Town of Washington Inland Wetlands Commission

APPLICATION TO MODIFY AN APPROVED PERMIT

**INLAND WETLANDS COMMISSION
SITE INSPECTION REPORT**

APPLICATION: MODIFICATION OF APPROVED PERMIT IW-20-07

TYPICAL - REINFORCED CONCRETE RETAINING WALL DETAIL
N.T.S.

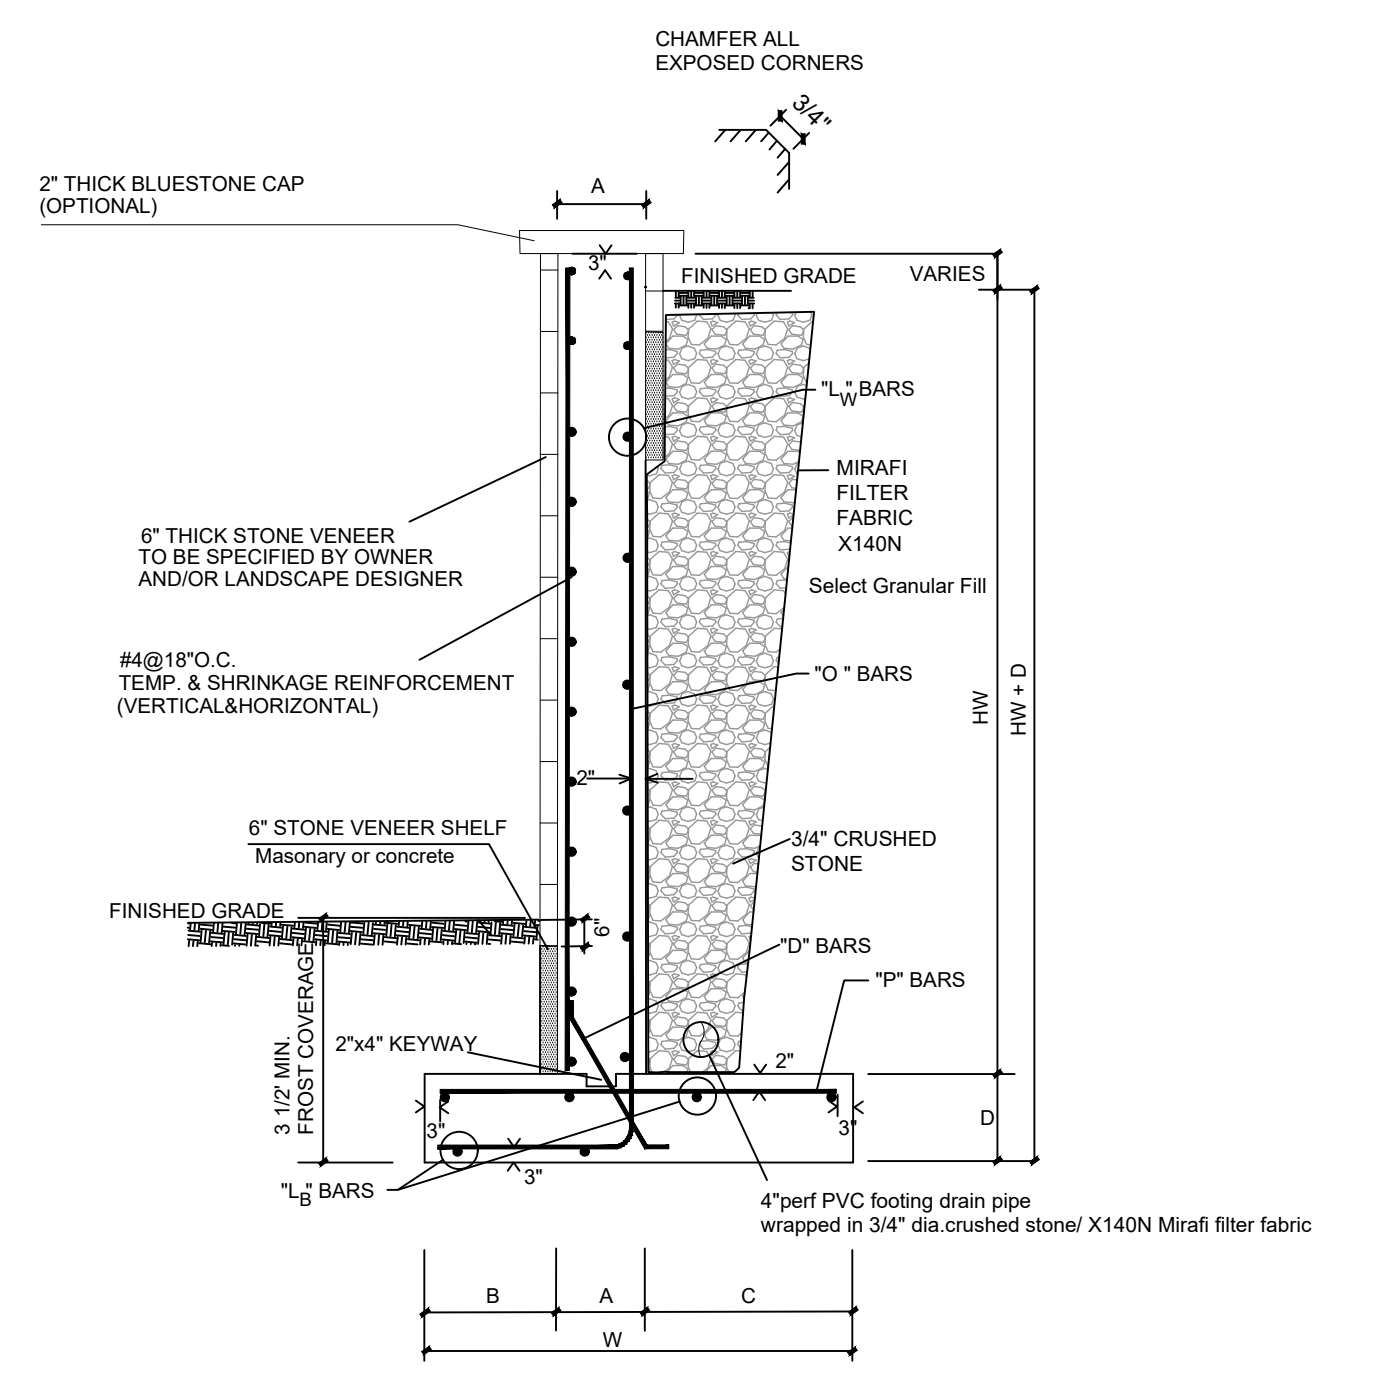
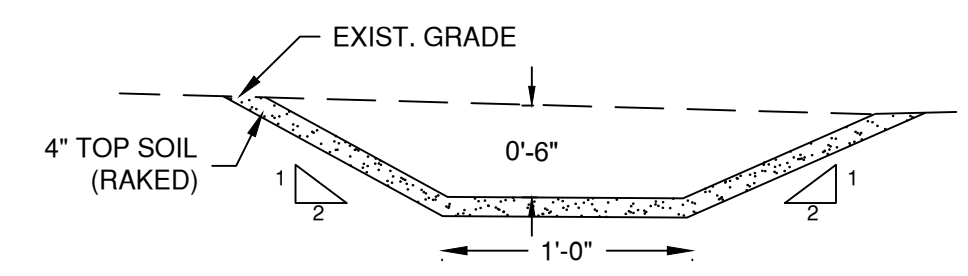
the edge of the retaining walls where it would be captured at three different locations by Yard Drains before linking on the southwestern corner of the existing large patio with a six-inch pipe that egresses downslope into an intermittent stream. Commissioners requested additional information as to the construction, materials, height and width of the proposed retaining walls.
